# Valdok I - Proposed New Residential Construction Project (DPD #3018670)

## Presentation Package

### SEATTLE DESIGN REVIEW

12.22.2014 | Early Design Guidance Meeting 1  
06.15.2015 | Design Review Recommendation Meeting 1

NORTH ELEVATION

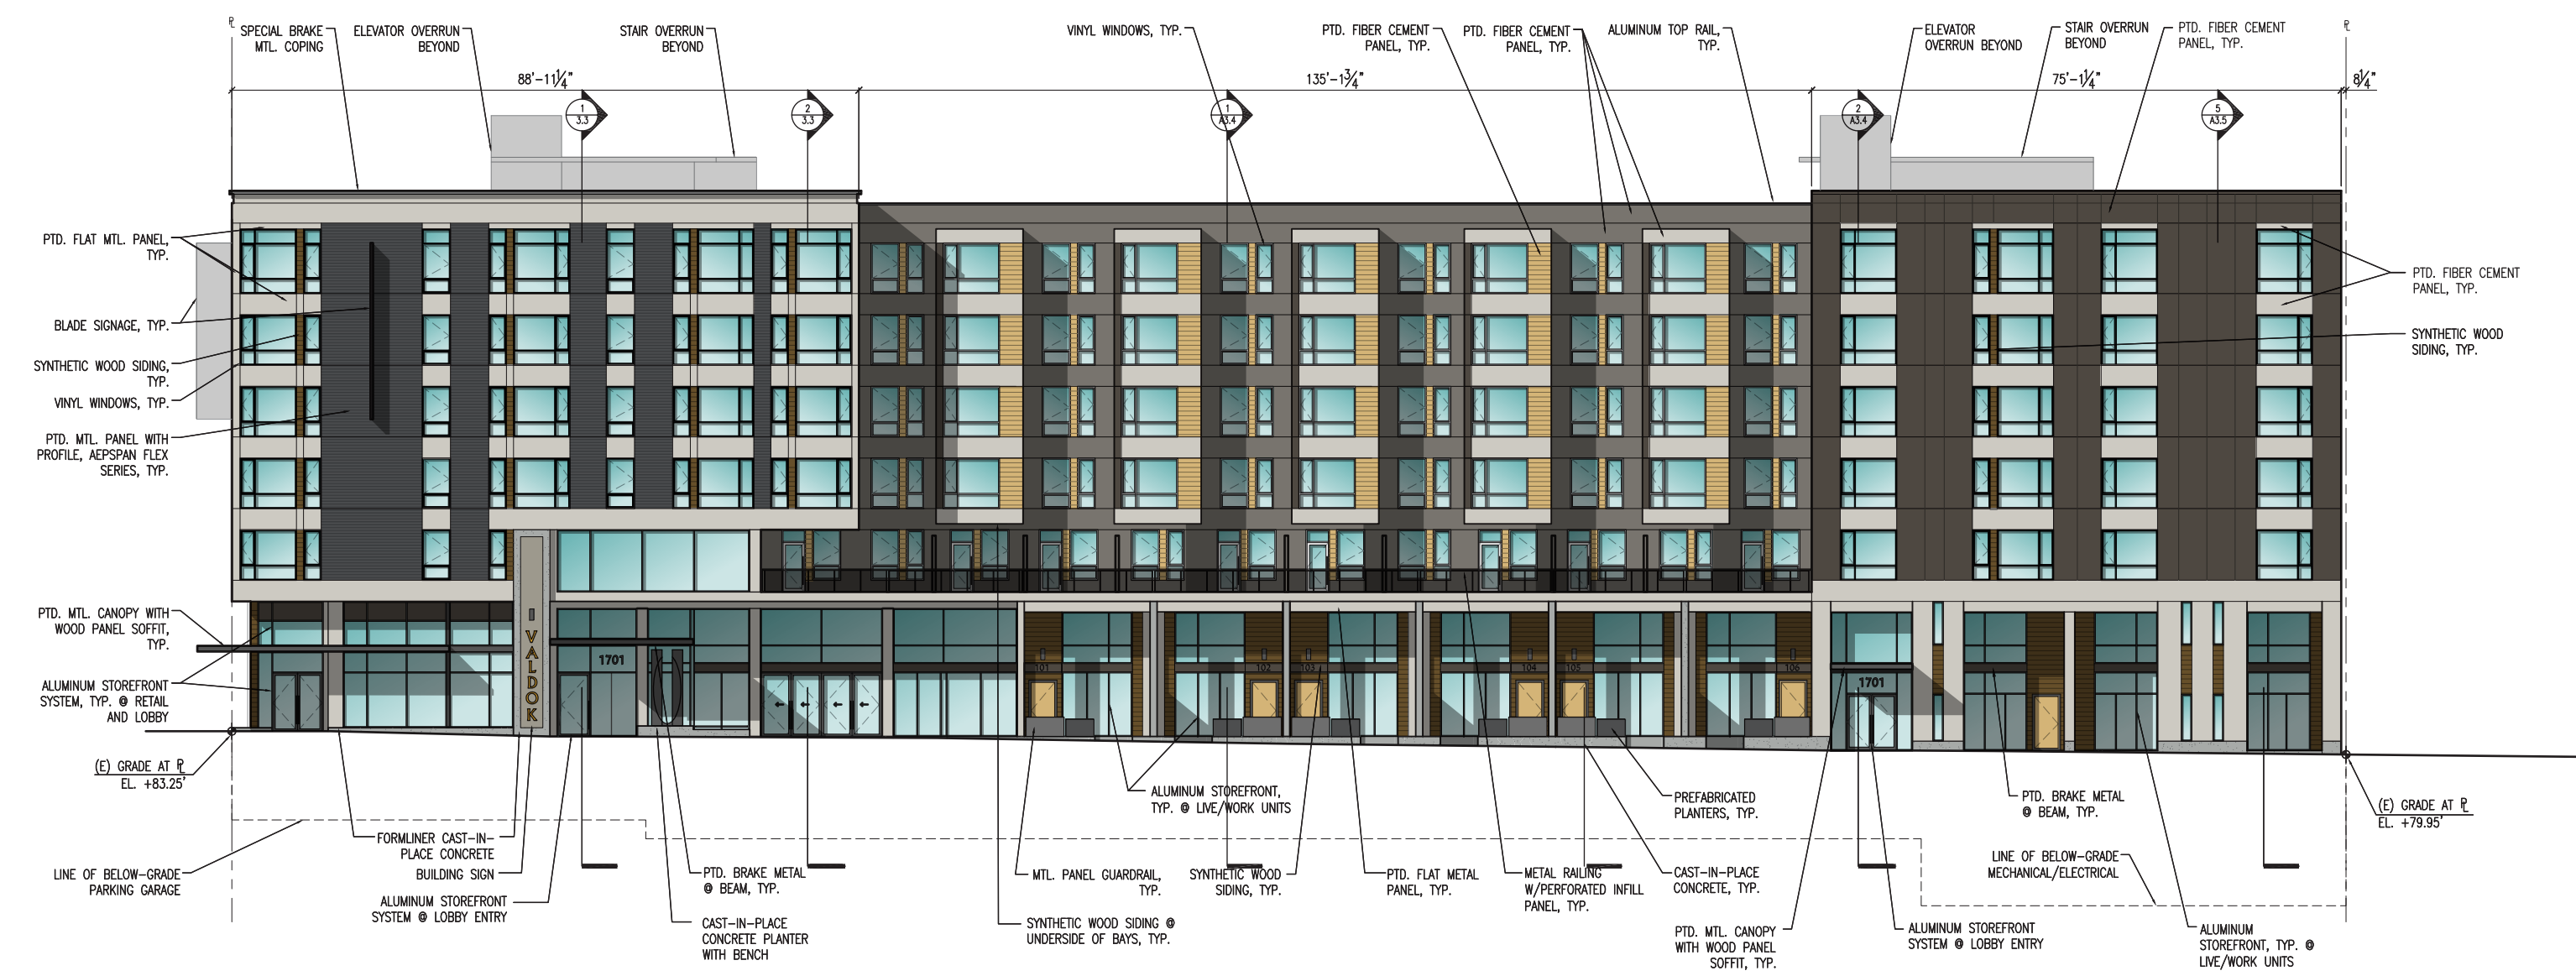
*“The Board supported the desire to create a contemporary look, utilizing quality materials and careful detailing. Reference was made during the presentation to the Scandinavian heritage of the locale, and some subtle reference was evident in the materials presented—if the reference is appropriate, it should be exploited and made more prominent and not totally subtle.”*
